Application Ref: NP/21/0060/FUL

Case Officer	Kate Attrill		
Applicant	Mr & Mrs Saber		
Agent	Mr G Gavin Oliver, Billystudio Architects		
Proposal	Replacement dwelling		
Site Location	Morwennau, Poppit, Cardigan, Pembrokeshire, SA43 3LP		
Grid Ref	SN15134849		
Date Valid	25-Jan-2021	Target Date	21-Apr-2021

This application is being brought to the Development Management Committee due to the Community Council recommendation differing to that of the Officers.

PROPOSED South-east elevation (field side)
1:100

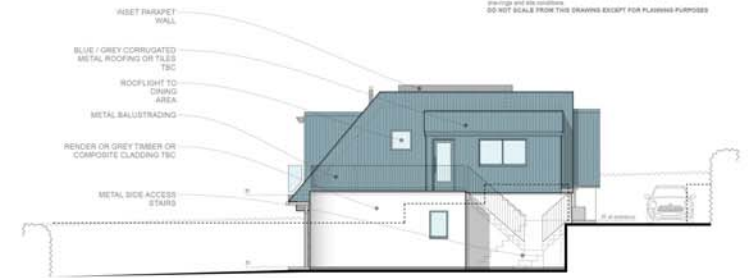
St Dogmaels Community Council objects to the proposals on the grounds that: The proposed design, incorporating a second dormer style window to the south east elevation is not in keeping with the style of the adjacent properties. A single dormer style window to the north east (sea view) would be considered to be far more in keeping with the local style.

The south east elevation dormer window offers views over the nearby property, Briar Bank, Poppit. The effect will be invasive and extremely detrimental the privacy of the residents. The proposed window will offer views into the main living areas of the nearby property and totally overlook the garden and terrace area. In order for this impact of the proposed design to be properly appreciated the Community Council requests that a site visit be made prior to any decision being taken.

The case officer has visited the site and observed that there is a degree of existing overlooking between these two properties. Standing adjacent to the bay window on the south eastern elevation of Morwennau, there is a clear view across the field to the rear elevation and patio area at Briar Bank.

Whether an additional first floor window at first floor level will exacerbate overlooking to such an extent as to be refusable is what the received objections hinge on.

There is undoubtedly a perception of increased overlooking, due to the additional height of the replacement dwelling, but in planning terms, a distance of 20 metres is considered adequate to protect normal levels of privacy between the frontages of buildings. In this case there is a distance of 46 metres between windows, and this is not considered sufficient grounds on which to refuse this application.

Rev A - 28.03.21 - Additional front and rear elevation
has been added to north-west elevation

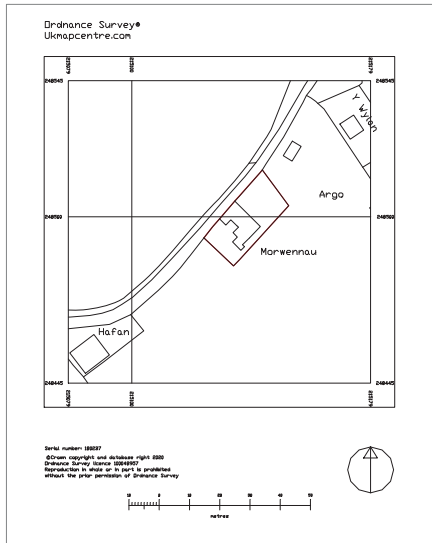
I recommend that the submitted drawings are updated with at least one more feature for bat roosting and one more feature for bird nesting to ensure compliance with the Environment (Wales) Act 2016. '

Revised plans incorporating enhancement were received on the 29th March and the Ecologists' further response as to their acceptability will be verbally reported to Committee.

1 x BIRD NESTING BOX
AS ECOLOGISTS
RECOMMENDATIONS
1 x BAT BOX AS ECOLOGISTS
RECOMMENDATIONS
